UNITED STATES PATENT AND TRADEMARK OFFICE

Office Action Summary	Application No. 10/500,496	Applicant(s) IGNATIUS, GEORG	
	Examiner William M. Pierce	Art Unit 3711

DETAILED ACTION

Fig.8

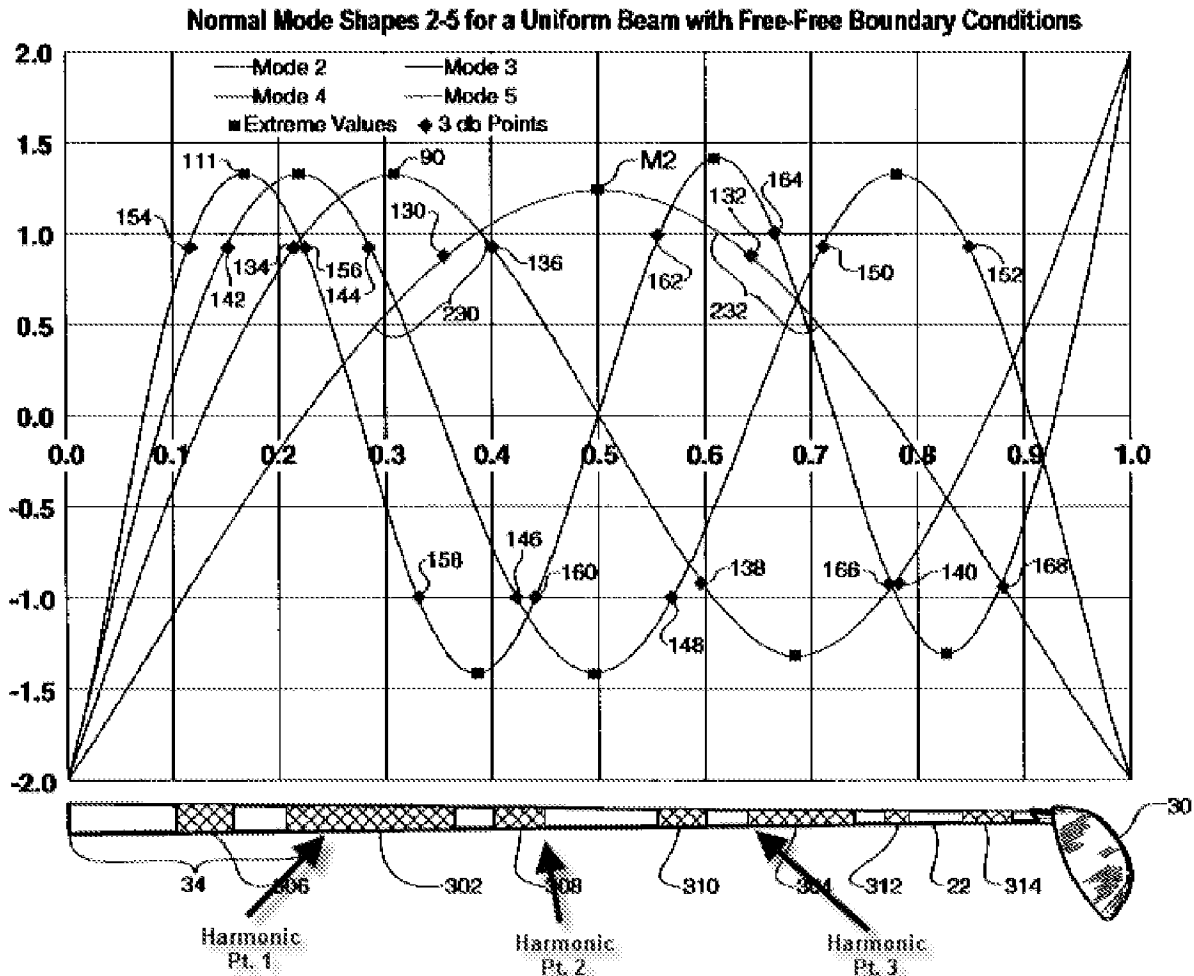
Where claims 35 and 49 now calls for the spacing of the locations of the active elements and the spacing between a location and an adjacent end to follow a harmonic series l/n . Most broadly, the scope of this limitation is such that the location of any number of active elements from a first end and second end must be equal. Wright is still considered to meet this limitation were at harmonic points 1-3 shown below are considered locations having an active element 302, 308 and 304.

As to claim 36, fig. 8 above shows a third harmonic. The locations of the active elements are also considered to be defined by a sixth harmonic series. Each element above differs in a dampening parameter based upon their different length as called for in claim 37. The elements shown above are considered over less than the length of the actuating part as called for by claim 38. The stiffeners of Wright are formed by applying
